RE: Knox Pit M2017-036  
Technical Revision 1– TR-1

TR-1 modifies Exhibits C and F to clarify the general backfill detail and how it will be constructed; specifically, the location of the drain and the liner keyed into the bedrock in relation to the compacted backfill for the pit liner.

**FIGURE 3  
 SUMMER 2017 GROUNDWATER  
 ELEVATIONS**

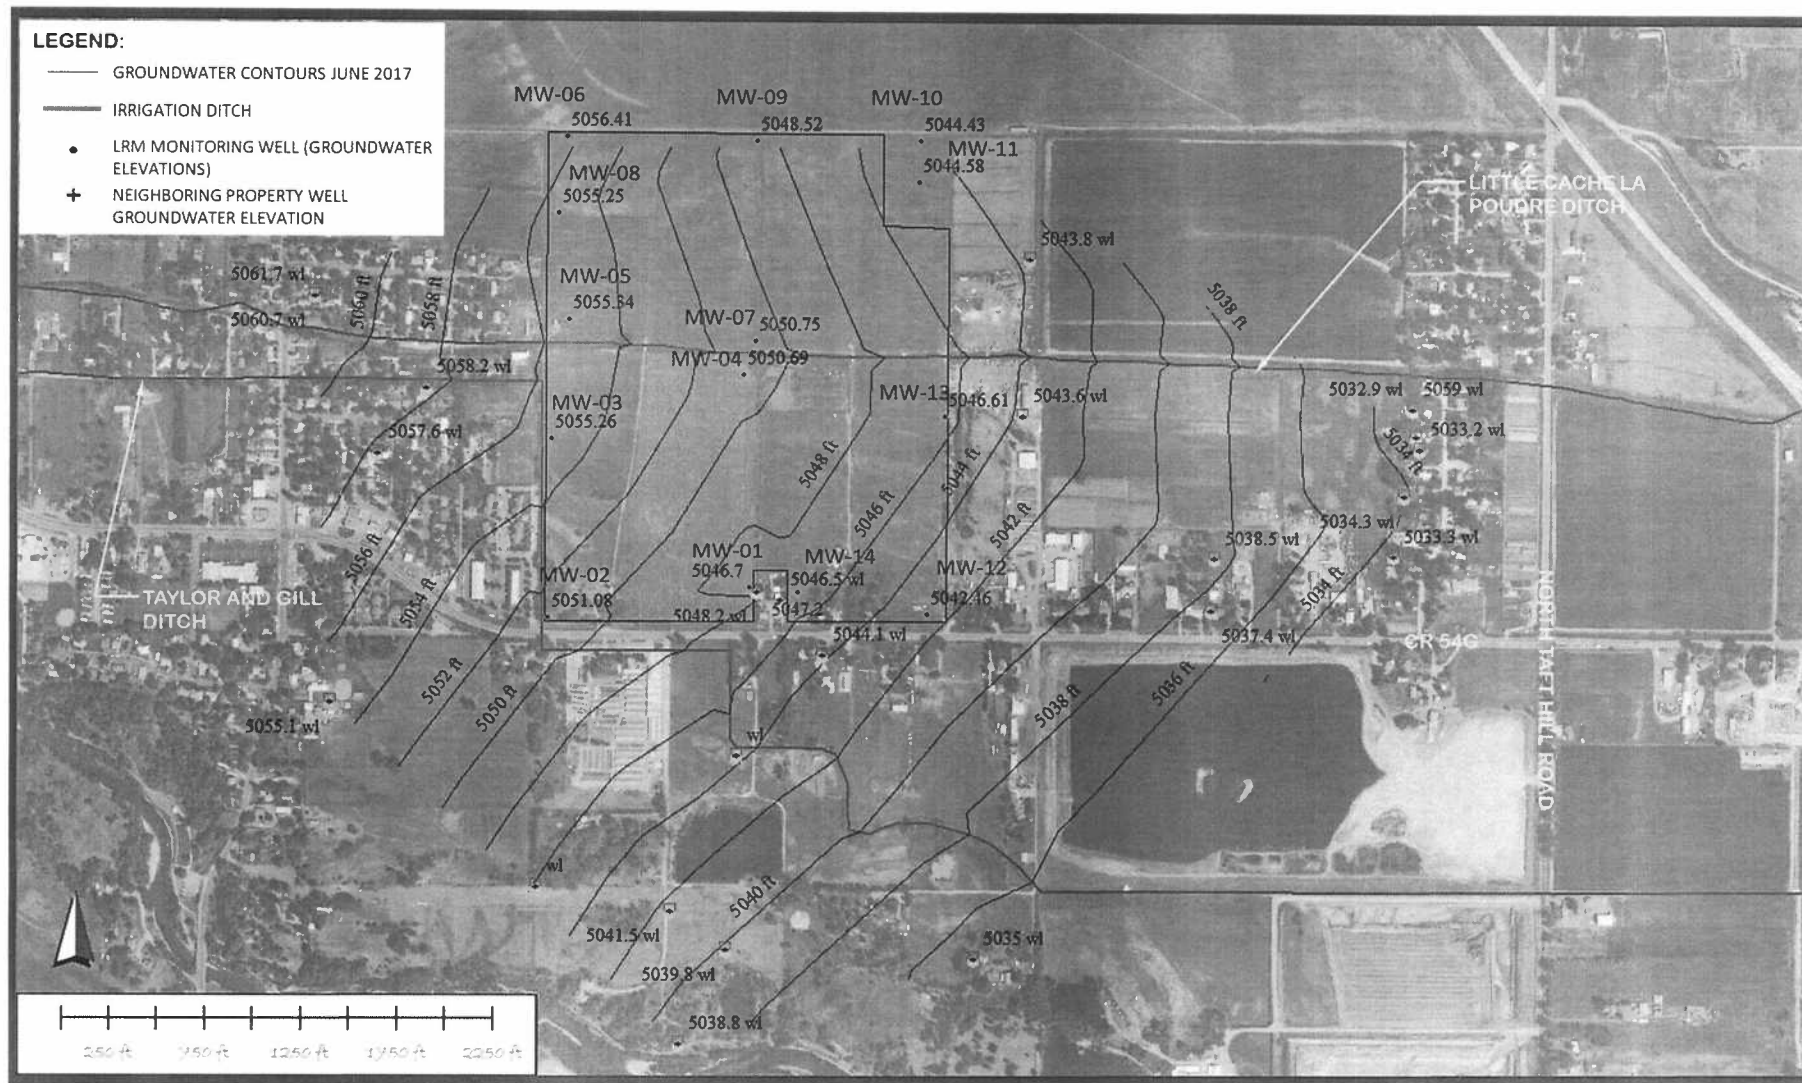
Section 7.1 of The Knox Pit Ground Water Study, Second Submittal, provides how the Monitoring Plan will address concerns that Selenium levels may potentially exceed the associated water quality standards through the trenches keyed into the weathered shale bedrock. The analysis and the Monitoring Plan provided in Section 7.1 continue to be the relevant evaluation and solution for addressing concerns.

Loveland Ready-Mix Concrete has collected over three years of baseline groundwater quality data and is committed to continue with quarterly monitoring throughout the life of the mine. At a minimum, results will be submitted to the Division with the annual report; however, any obvious discrepancies or changes to established baseline values will be immediately provided to the Division.

Figure 1  
LRM - Knox Pit (M2017-036) – Compliance Well Locations

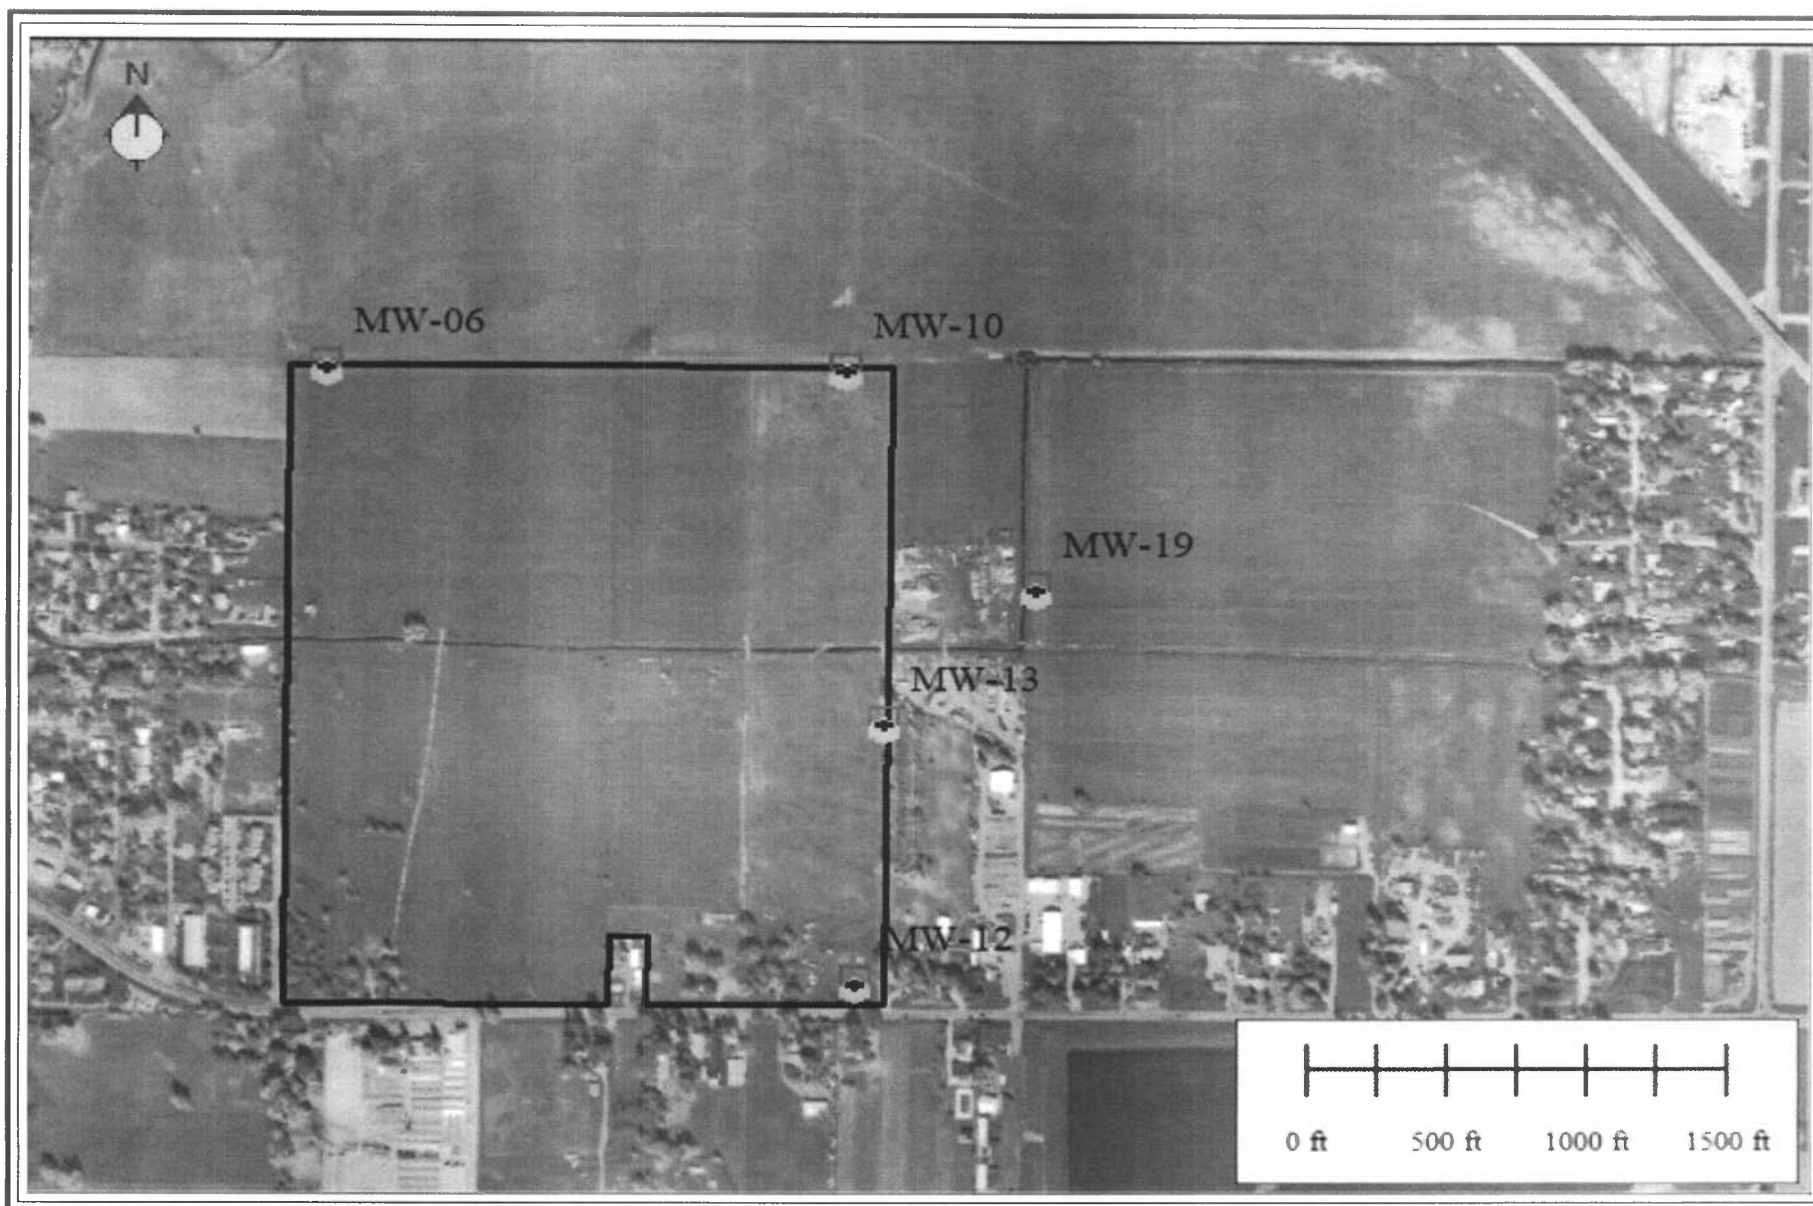
*19. To minimize potential impacts to groundwater quality, including through any leaching of selenium, Applicant is required to establish baseline groundwater quality prior to mining and continue monitoring throughout the life of the mine. Once the mining operation begins, groundwater quality samples will be taken quarterly, with results submitted to the Division in the Applicant's annual report. At all times, Applicant must comply with Colorado Department of Health and Environment Water Quality Control Commission standards. During the hearing, Applicant committed to continue monitoring for selenium and represented that they will run full spectrum tests as part of their water quality monitoring plan.*
